STATE OF TENNESSEE
DEPARTMENT OF TRANSPORTATION
BUREAU OF ENGINEERING

I-65 INTERCHANGE AT BUCKNER ROAD
IN SPRING HILL (DESIGN-BUILD)

REV. 09/14/20: REVISED INDEX OF SHEETS.

TYPE	YEAR	PROJECT NO.	SHEET NO.
FUNCT.	2020		11A

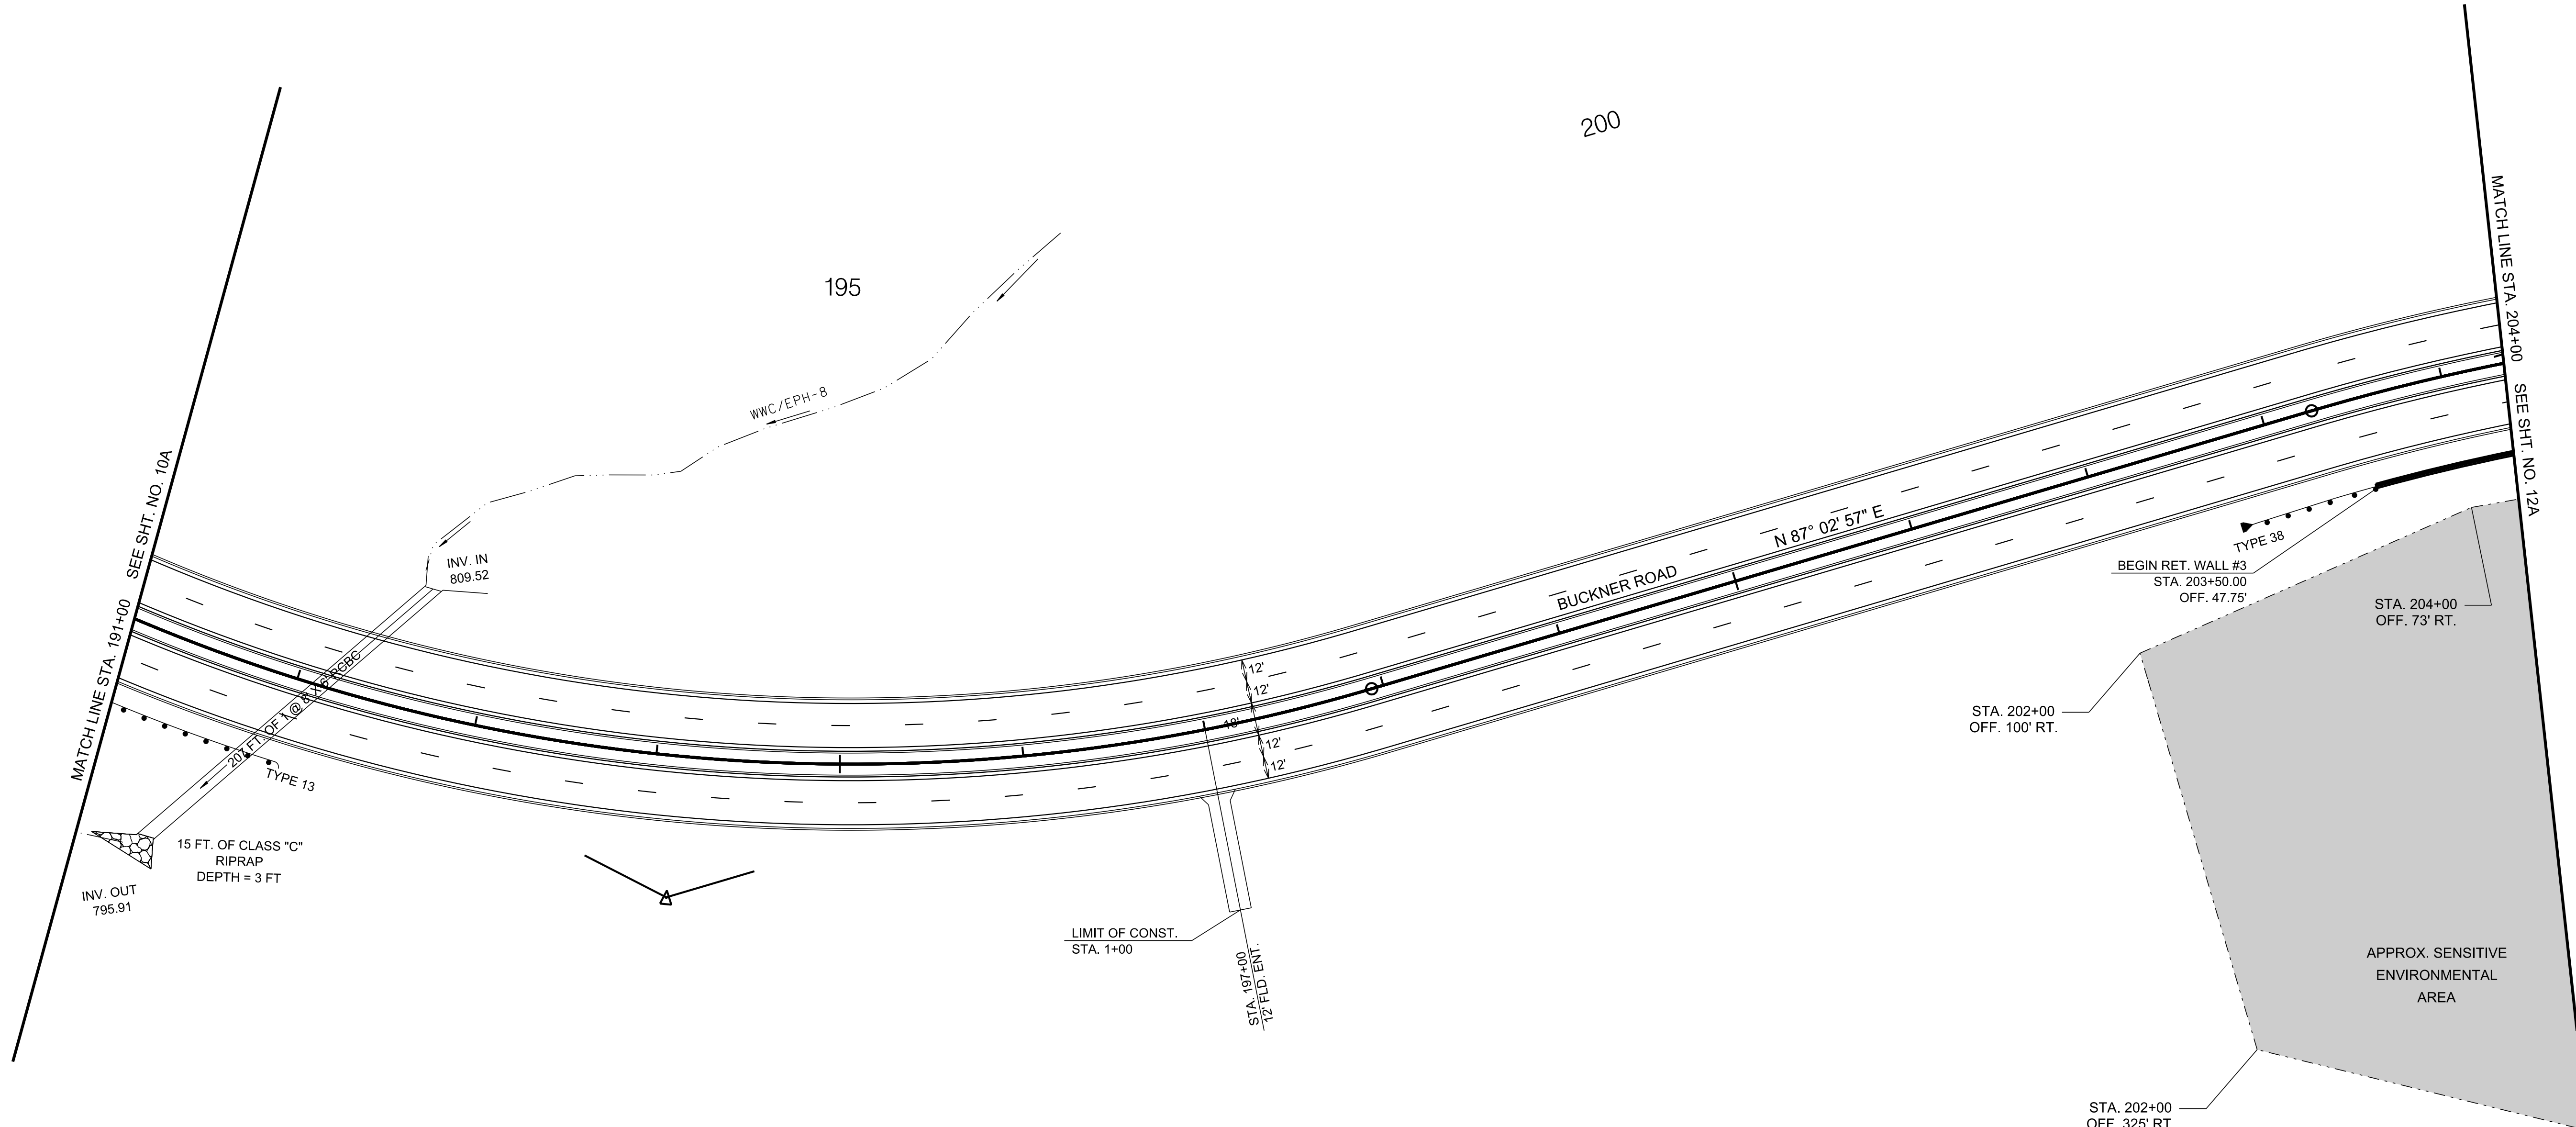
REV. 09/14/20: ADDED FIELD ENTRANCE FOR TRACT NO. 25. REVISED 8'X6' RCBC AT STA. 192+13.13 AND REVISED GUARDRAIL.

TYPE	YEAR	PROJECT NO.	SHEET NO.
FUNCT.	2020		12

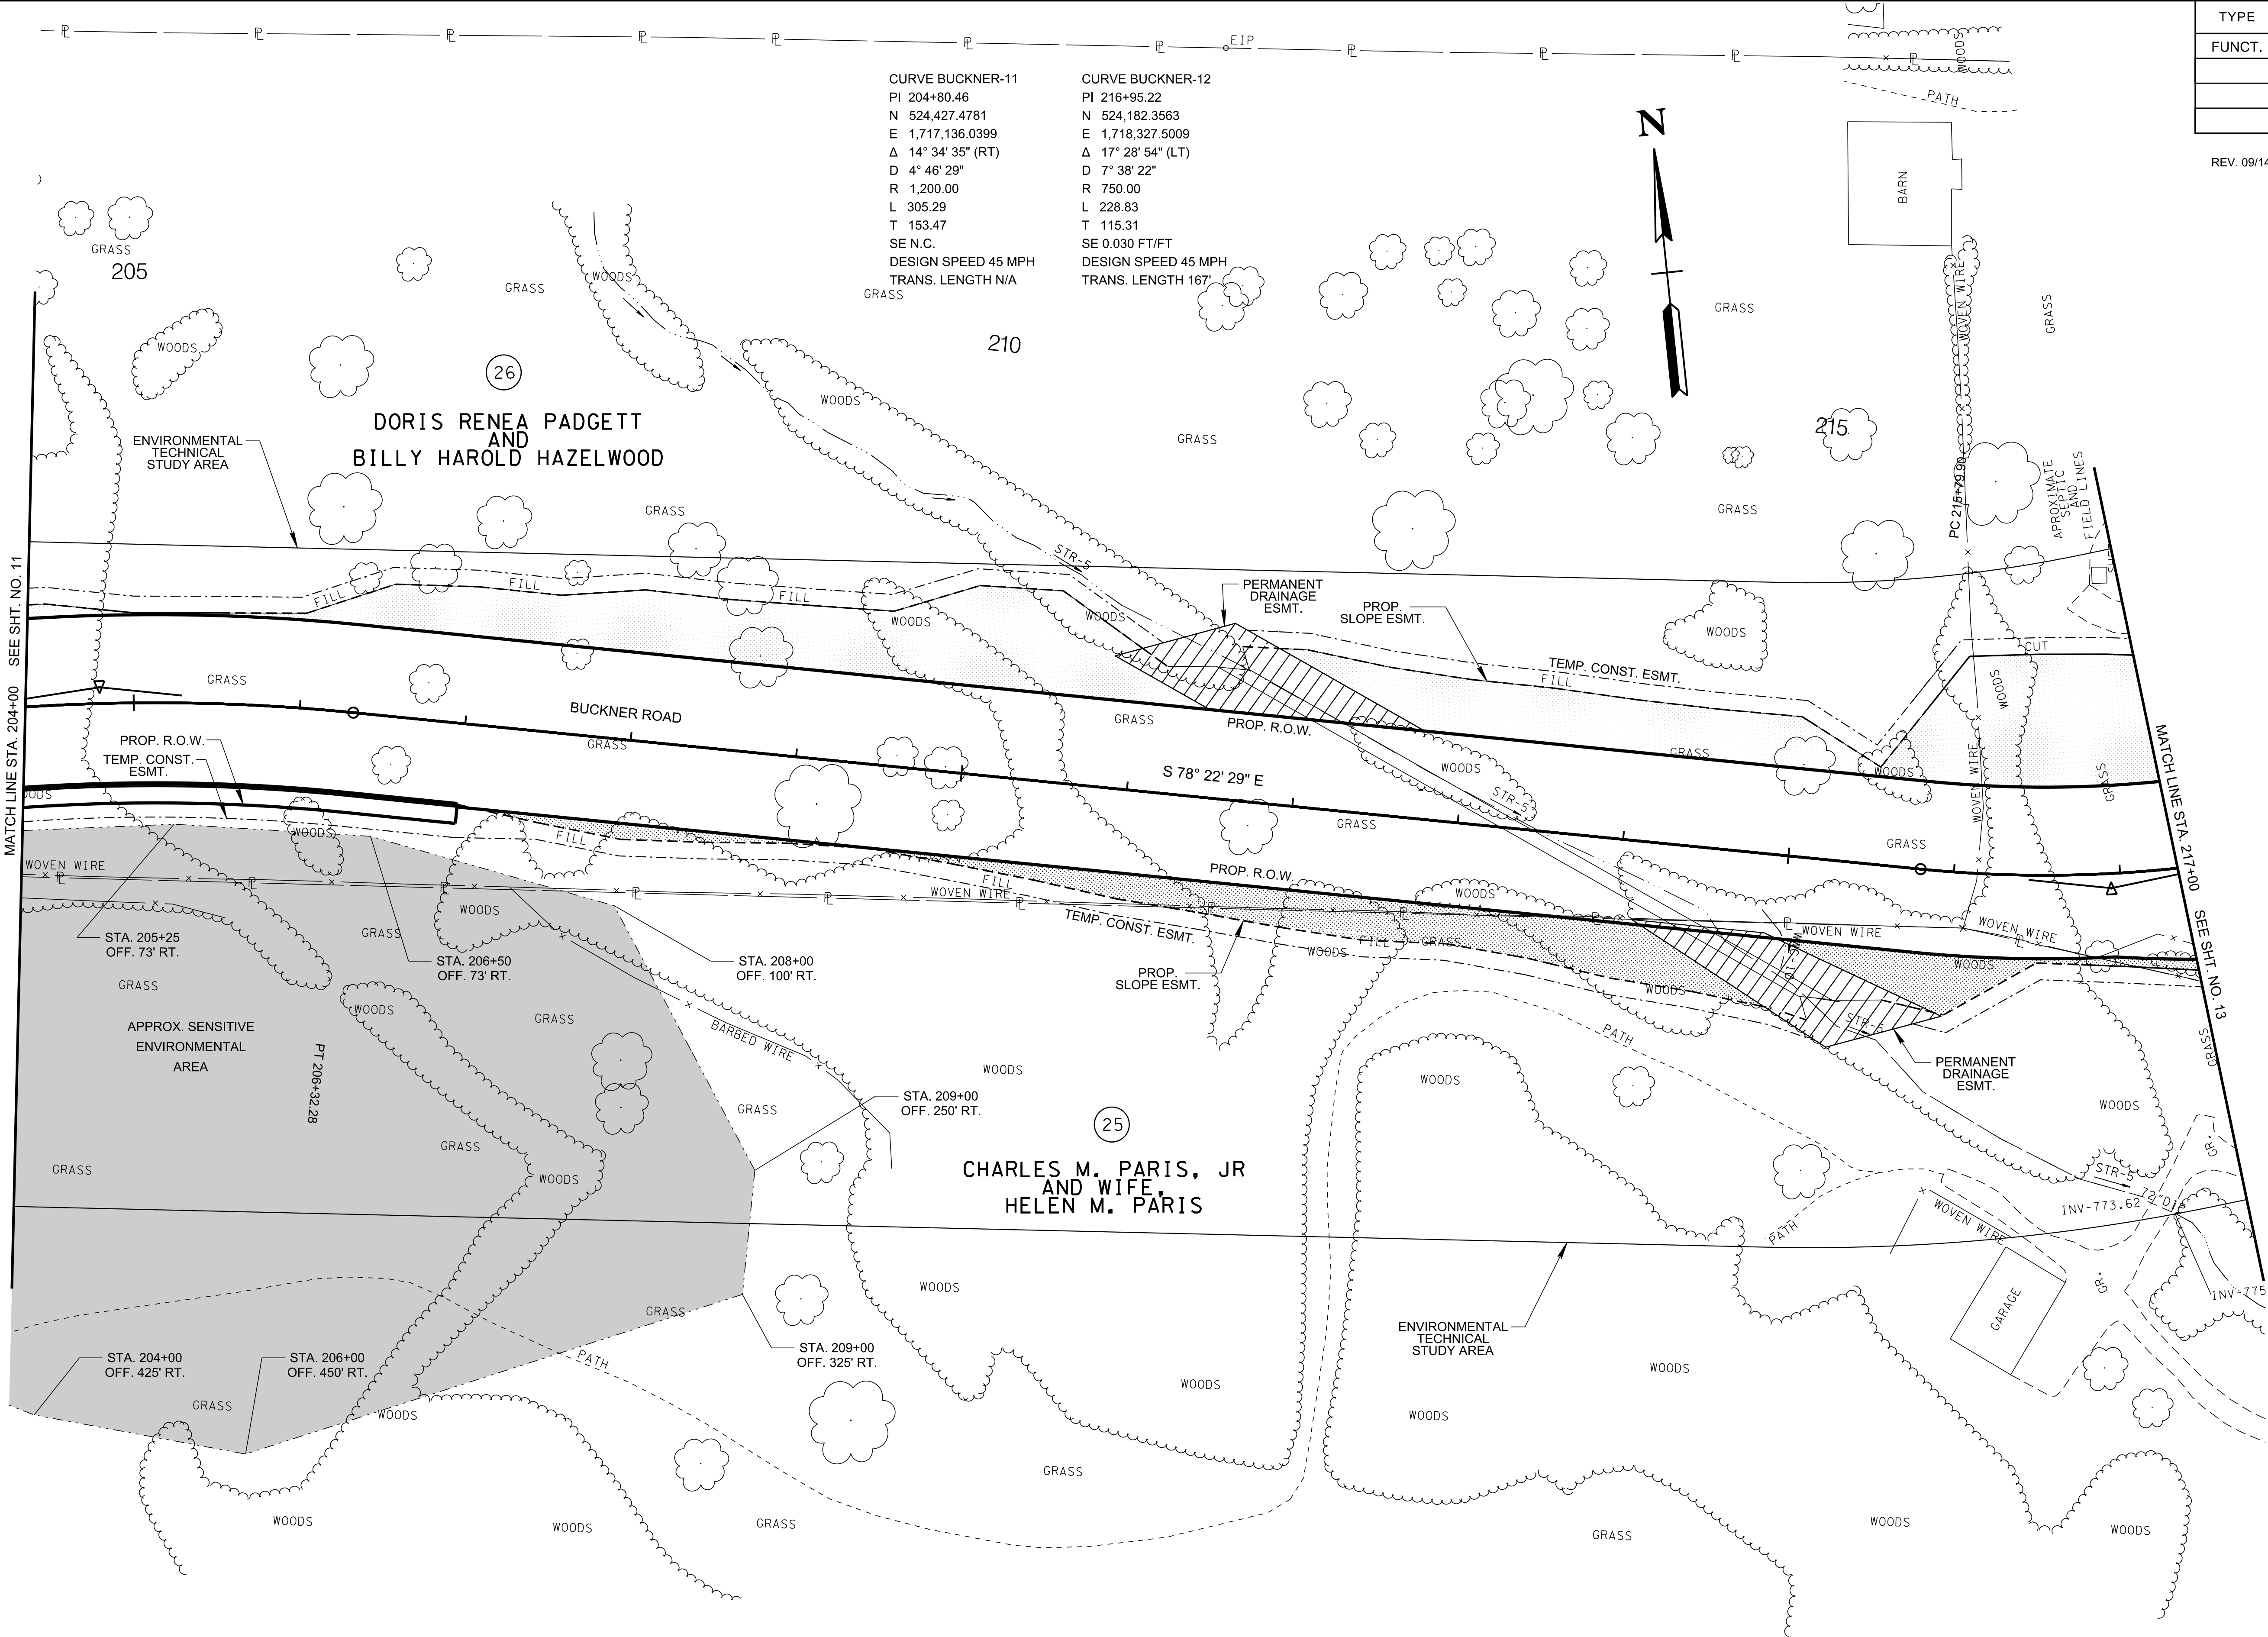
REV. 09/14/20: REVISED 8'X6' ROBC AT STA. 213+35.62.

TYPE	YEAR	PROJECT NO.	SHEET NO.
FUNCT.	2020		12A

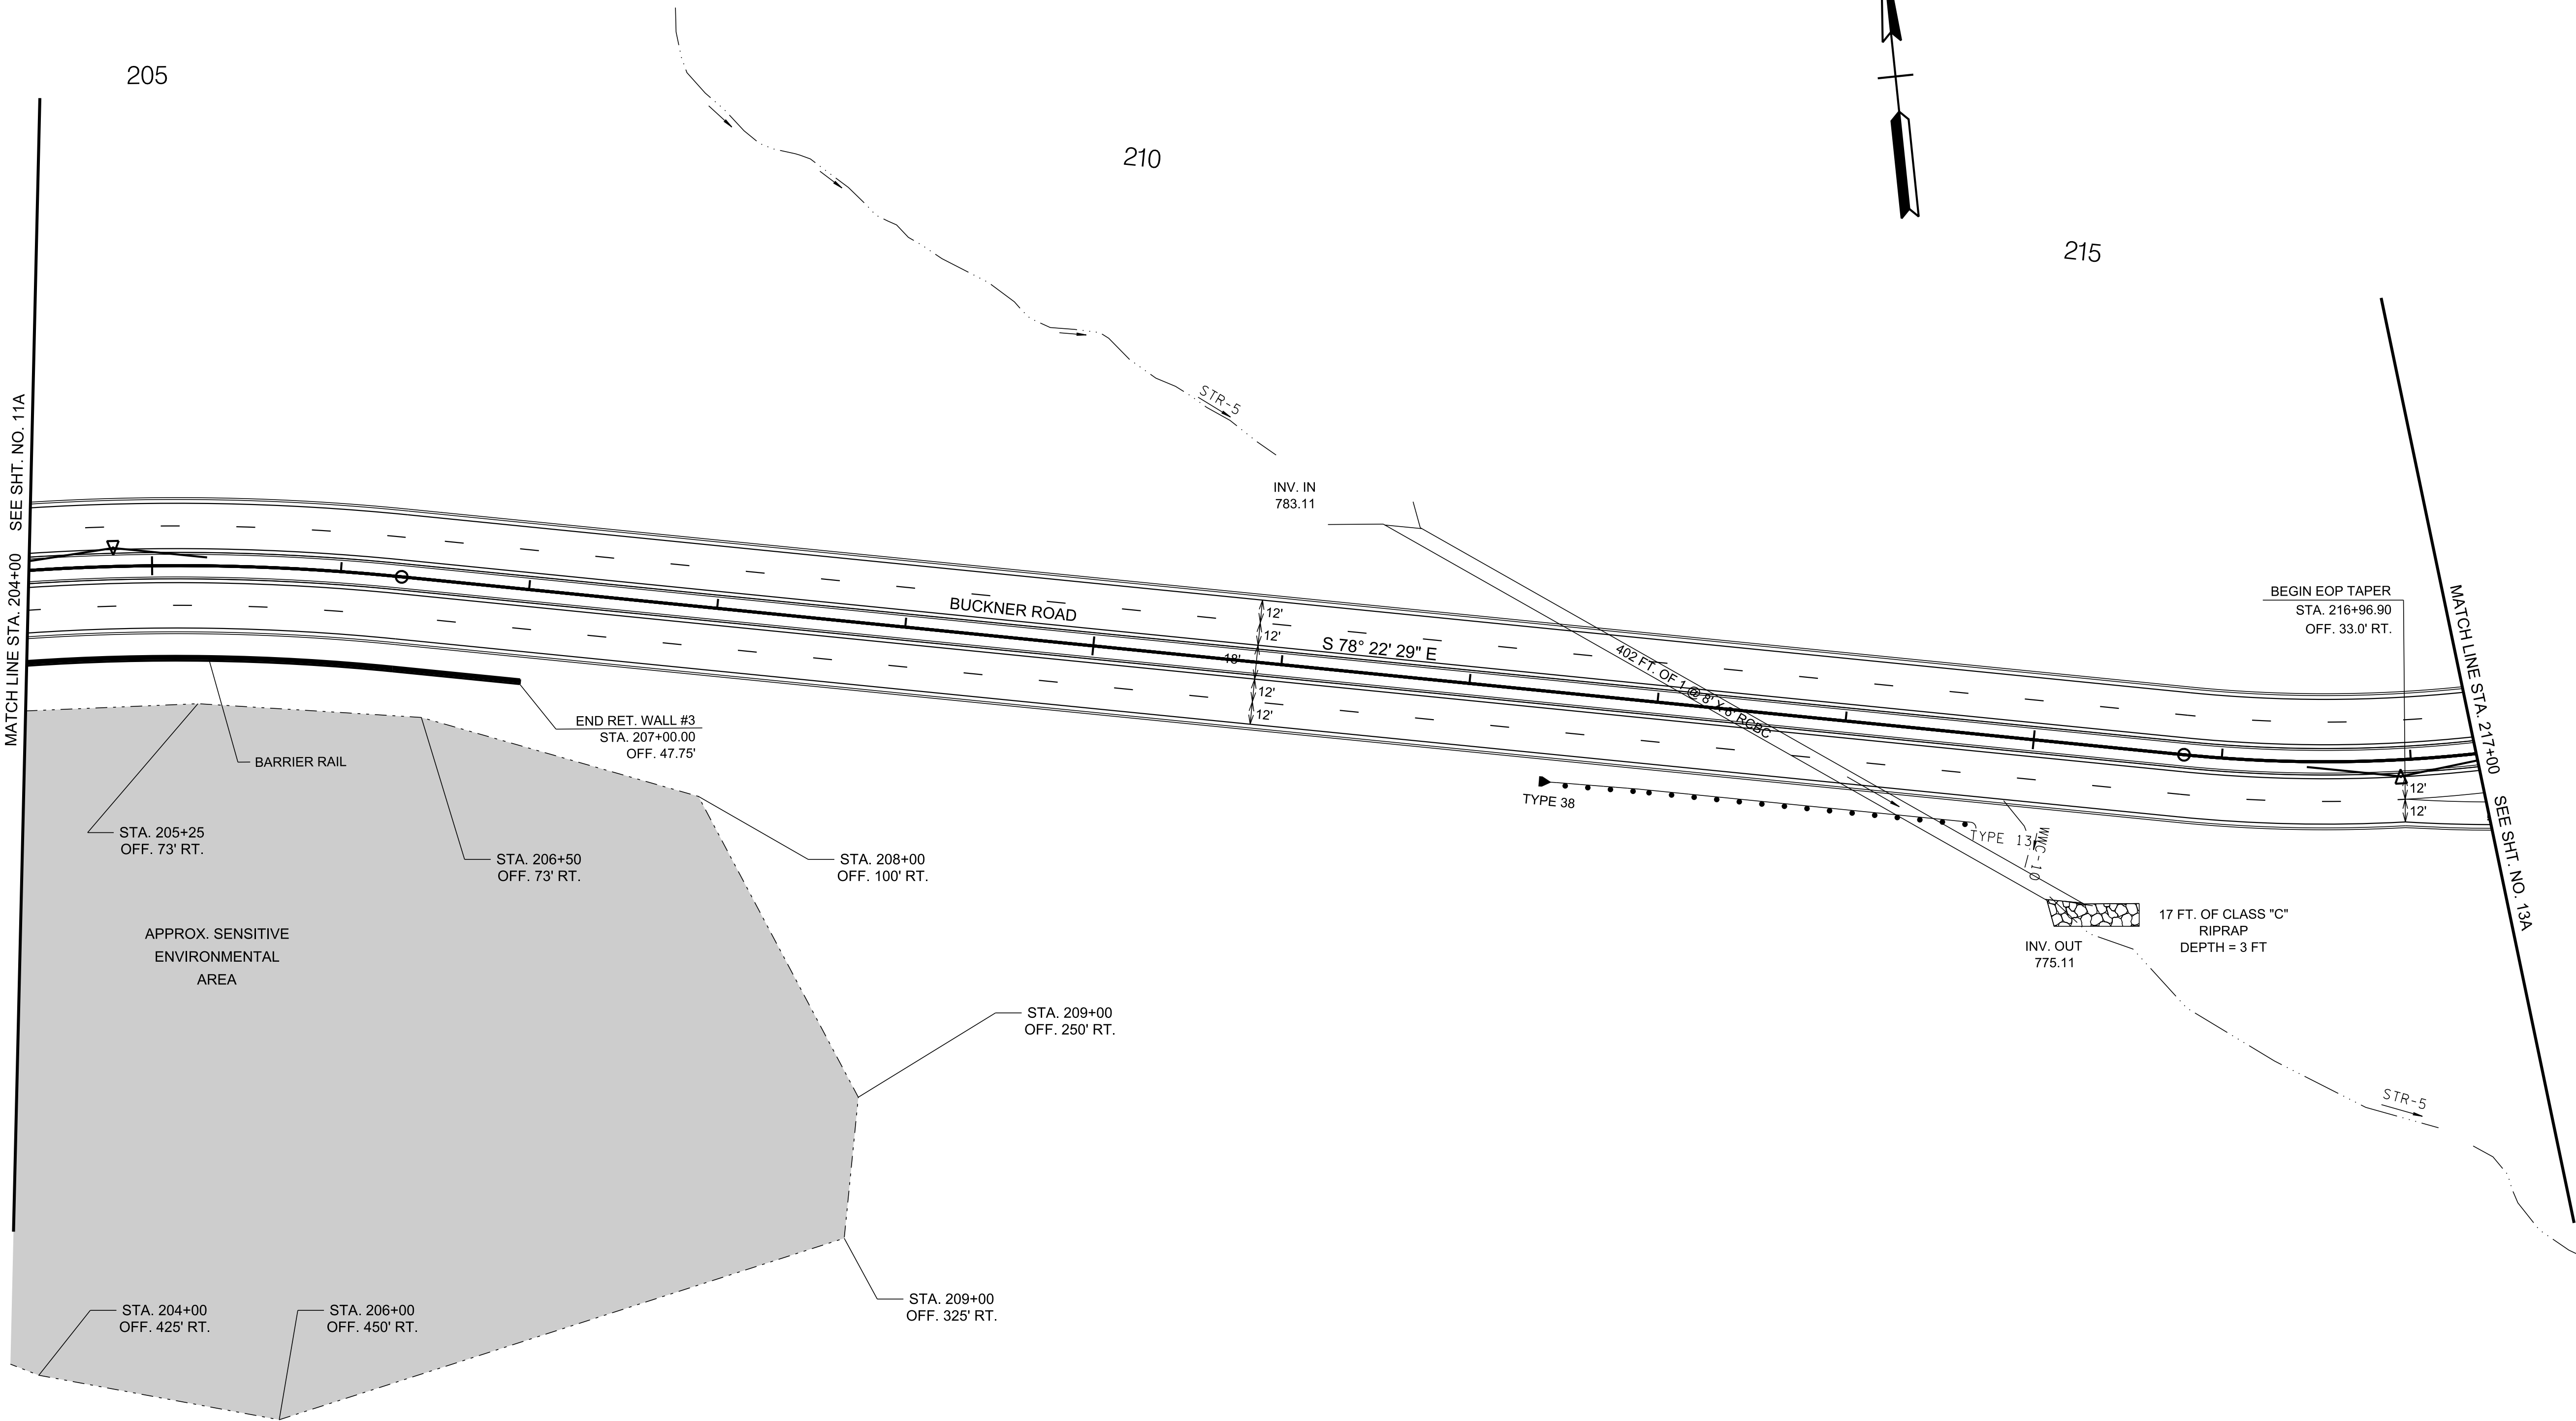
REV. 09/14/20: REVISED 8'X6' ROBC AT STA. 213+35.62 AND REVISED GUARDRAIL.
